**FINAL PRODUCT/PROCESS CHANGE NOTIFICATION # 20253**Generic Copy

**Issue Date:** 22-Oct-2013**TITLE:** Qualification of ON Semiconductor Vietnam (OSV) for the Assembly and Test of Ultrafast Rectifiers packaged in the TO220FullPak and Transition to a New Case Outline**PROPOSED FIRST SHIP DATE:** 22-Jan-2014**AFFECTED CHANGE CATEGORY(S):** ON Semiconductor Assembly & Test**FOR ANY QUESTIONS CONCERNING THIS NOTIFICATION:**Contact your local ON Semiconductor Sales Office or following contact Product Engineer:  
Raja Roziah Raja Rahmat <[Raja.Roziah.Rahmat@onsemi.com](mailto:Raja.Roziah.Rahmat@onsemi.com)>**SAMPLES:** Contact your local ON Semiconductor Sales Office**ADDITIONAL RELIABILITY DATA:** AvailableContact your local ON Semiconductor Sales Office or Reliability Engineer Chean Ching Sim  
<[cheanching.sim@onsemi.com](mailto:cheanching.sim@onsemi.com)>**NOTIFICATION TYPE:**

TO-220 FULLPACK, 2-LEAD  
CASE 221AG

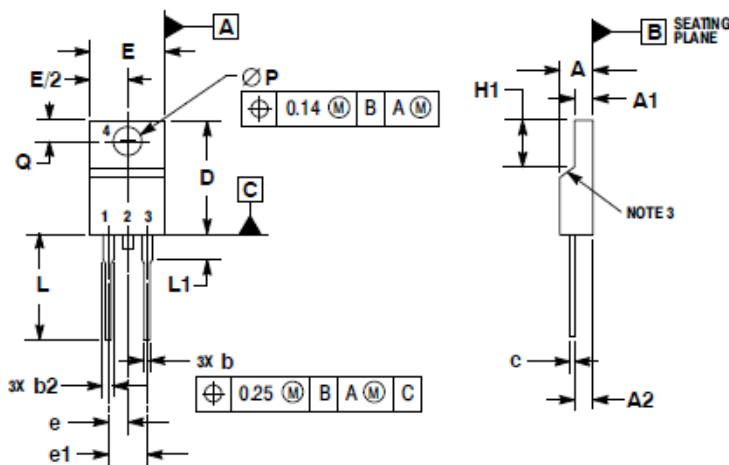
ON Semiconductor is transitioning the assembly and test of ultrafast rectifiers packaged in the TO-220 Fullpack from SP Semi, Korea to ON Semiconductor Vietnam (OSV). This includes a change in the case outline to a more compact form factor. The case outline change is in response to customer requests for a package outline matching that of MOSFETs commonly paired with these devices. Case outlines 221E and 221D will transition to case outlines 221AG and 221AH respectively.

Comparison between case outline
